## APPLICATION FOR MODIFICATION ASSESSMENT REPORT

<b>Application Number:</b>	Mod2022/0471
<b>Responsible Officer:</b>	Gareth David
<b>Land to be developed (Address):</b>	Lot 1 DP 373531, 1955 Pittwater Road BAYVIEW NSW 2104
<b>Proposed Development:</b>	Modification of Development Consent DA2019/0154 granted for demolition works and construction of a seniors housing development
<b>Zoning:</b>	R2 Low Density Residential
<b>Development Permissible:</b>	Yes, under Yes, under SEPP (Housing for Seniors or People with a Disability) 2004
<b>Existing Use Rights:</b>	No
<b>Consent Authority:</b>	Northern Beaches Council
<b>Delegation Level:</b>	DDP
<b>Land and Environment Court Action:</b>	No
<b>Owner:</b>	Ian Francis Westaway Jan Elizabeth Westaway J A Westaway & Son (Developments) Pty Ltd Cap One Developments Pty Ltd
<b>Applicant:</b>	The Trustee For The 1955 Pr Bay Unit Trust
<b>Application Lodged:</b>	29/09/2022
<b>Integrated Development:</b>	No
<b>Designated Development:</b>	No

The application seeks to modify Development Consent No.DA2019/0154 which was granted for a seniors housing development by the NSW Land and Environment Court.

**Figure 1:** Section Plan - Height of building variation in pink (based off pre-existing extrapolated ground levels as assessed within DA2019/0154)

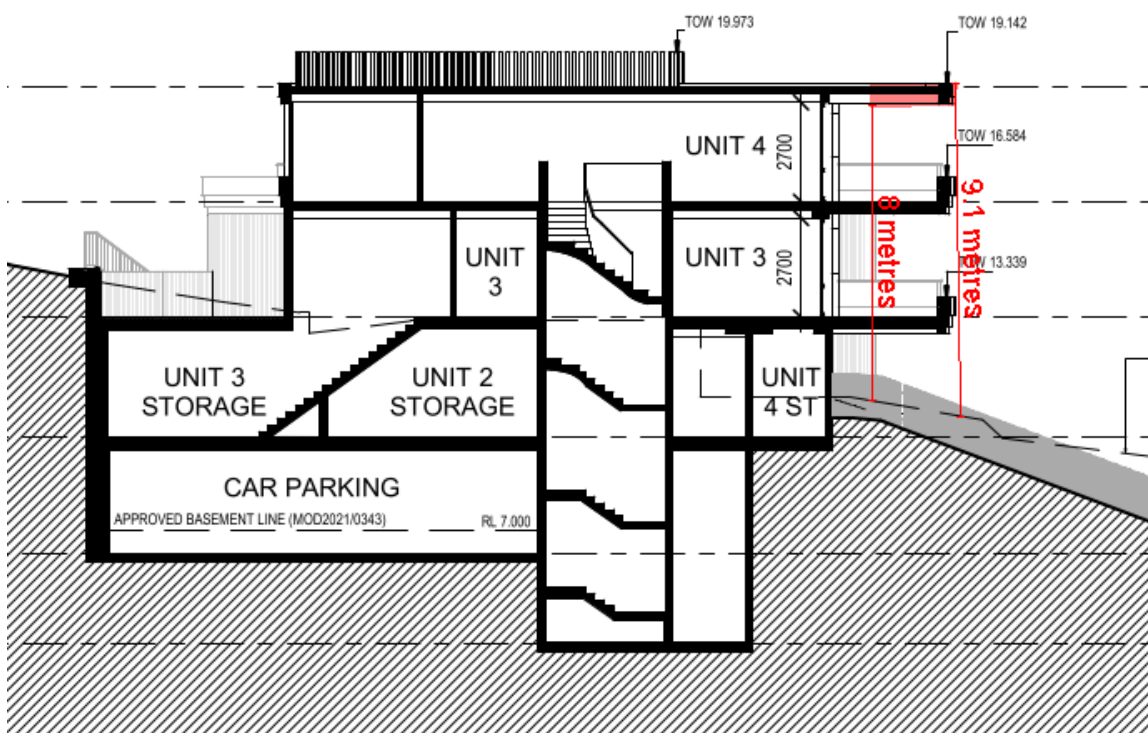
- The ceiling height of Unit 4 was approved within DA2019/0154 at RL18.2. The modification seeks a new ceiling height of Unit 4 of RL18.493 which will result in an increase in height of **293mm**. The unit 4 terrace roof will also extend to the north-east (downslope) by approximately 1.0m. This will result in the maximum ceiling height of Unit 4 being 8.5m which is non-complaint with the 8.0m requirement. It is of note that this will occur for a minor section of the terrace ceiling which is located centrally onsite. This is depicted in Figure 1 below. The remainder of the ceiling will comply with the 8.0m requirement.

- The parapet height of the roof ridge (located over unit 4) was approved within DA2019/0154 at RL18.48. The modification seeks a new parapet height of RL19.142, which will result in an increase in height of **662mm**. The Unit 4 terrace roof will also extend to the north-east (downslope) by approximately 1.0m. This will result in the overall roof height measuring

9.1m. This is depicted in Figure 1 below. It is of note that this will occur for a minor section of the terrace roof which is located centrally onsite.

**Figure 2:** Section Plan - Height of building variation in pink (based off pre-existing extrapolated ground levels as assessed within DA2019/0154)

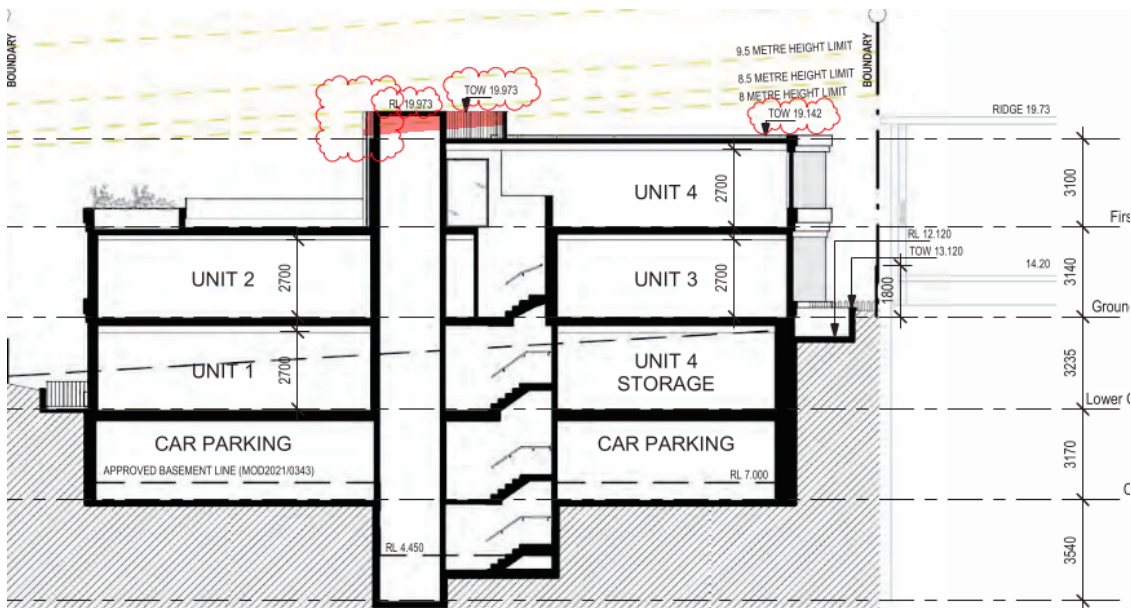
- The modification application also seeks approval for rooftop plant including lift overrun, and associated enclosure/screening with an RL of 19.973, which will result in an increase in height of **1.49m** from the approved ridge height for these elements. This will result in the overall height measuring approximately 9.3m (from pre-existing extrapolated ground levels). This is depicted in figure 2 below.

**Photo 6:** Existing views from No.60 Alexandra Crescent to the north-east (ground floor rear garden/private open space).

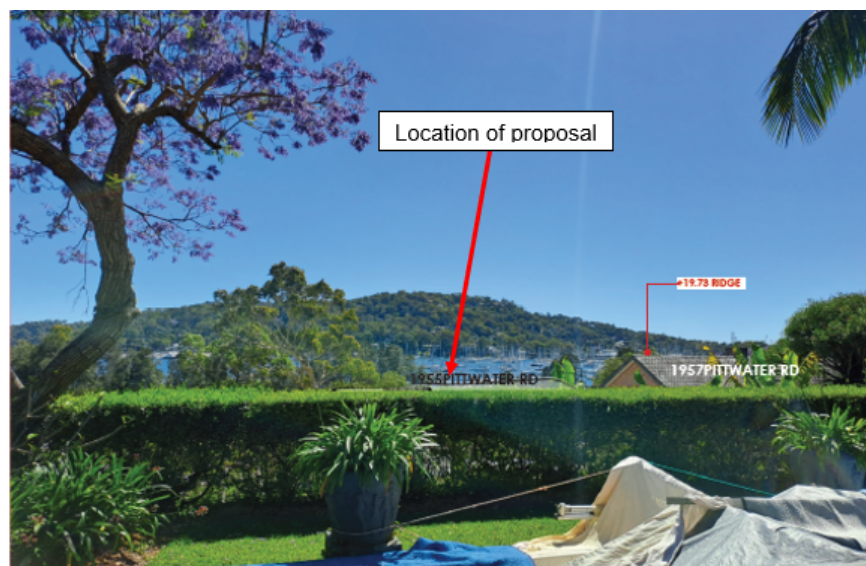
*Note\* : Photomontage of the proposal prepared by the applicant within the submitted "View Study Analysis" (prepared by APLUS DESIGN GROUP) using site inspection photos taken by Council's Planning Officer.*

**Photo 9:** Existing views from No.62 Alexandra Crescent to the north-east (upper floor balcony located off living rooms).

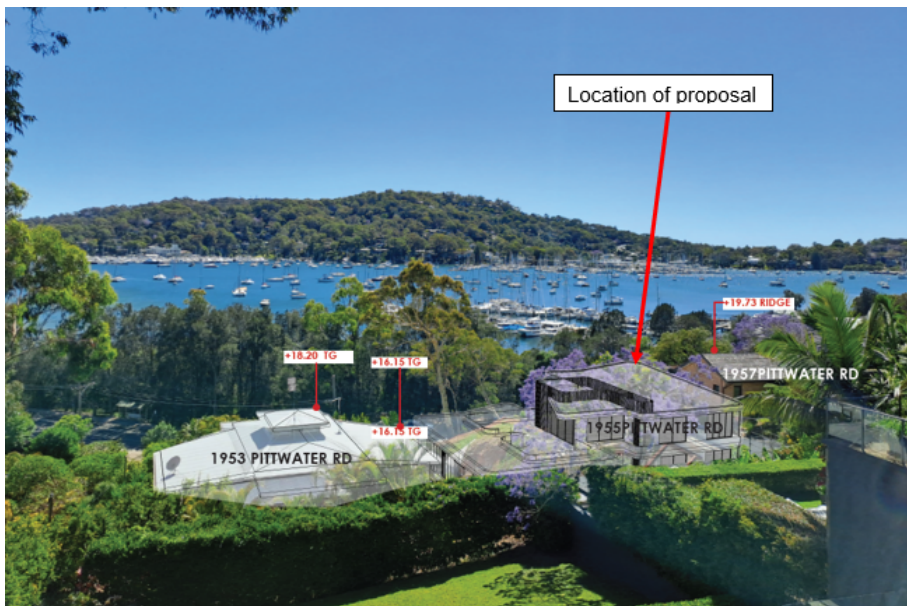
The views from No.62 Alexandra Crescent that are the concern are to the north-east and include views of Pittwater Waterway. The view is partially obstructed by existing vegetation. Expansive views of Pittwater waterway, land and water interface, Scotland Island and foreshore areas to the north and north-west remain unaffected by the proposal. This is demonstrated below in the photos and view assessment photomontages prepared by the applicant.

Note\* : Photomontage of the proposal prepared by the applicant within the submitted "View Study Analysis" (prepared by APLUS DESIGN GROUP) using site inspection photos taken by Council's Planning Officer.

**Photo 9:** Existing views from No.62 Alexandra Crescent to the north-east (ground floor private open space).

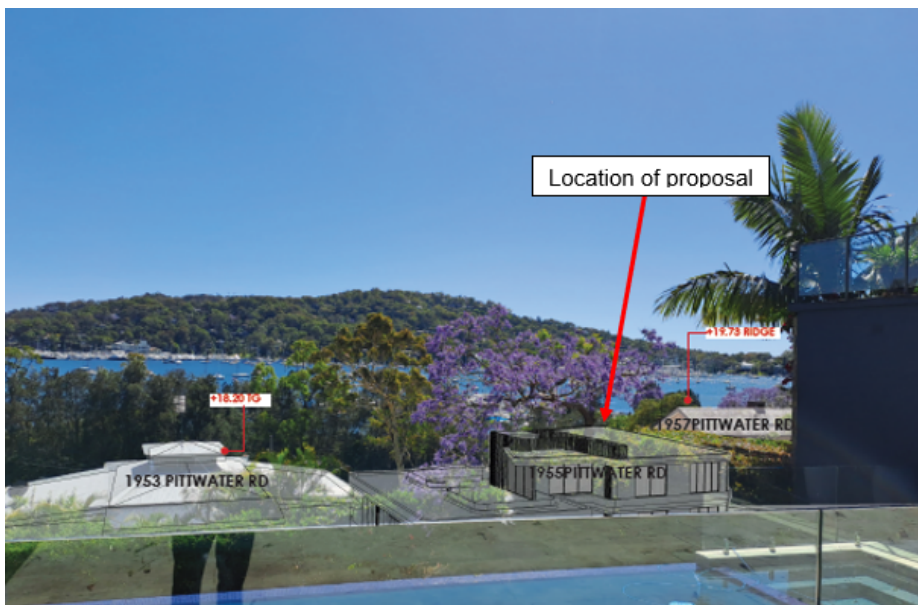
Note\* : Photomontage of the proposal prepared by the applicant within the submitted "View Study Analysis" (prepared by APLUS DESIGN GROUP) using site inspection photos taken by Council's Planning Officer.

**Figure 1 - Building envelope non-compliance (shown in shaded red)**

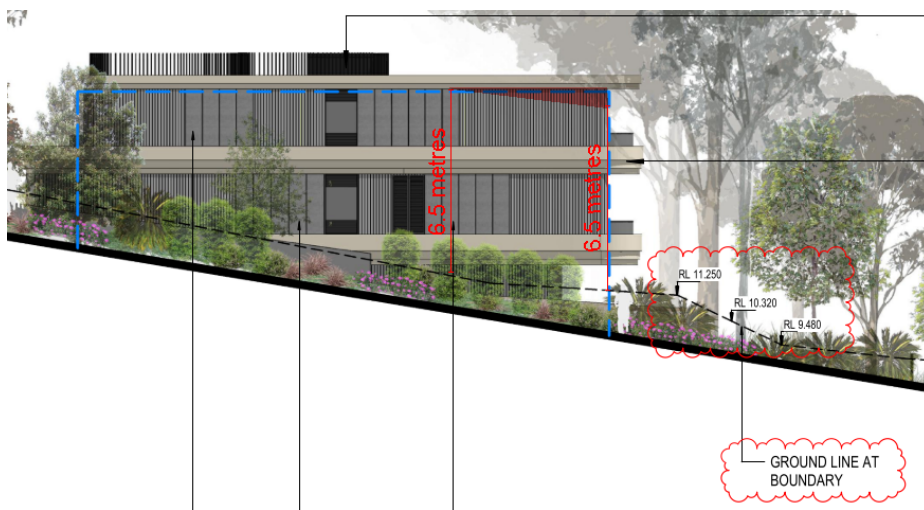
The proposal has a minor encroachment into the prescribed building envelope along the eastern elevations. This variation is represented in Figure 1 below.

Clause D4.8 includes a variation which specifies that eaves or shading devices that provide shade in summer and maximise sunlight in winter, shall be permitted to extend outside the building envelope. Therefore the roof eaves and parapet additions subject of this modification is not applicable to this assessment.
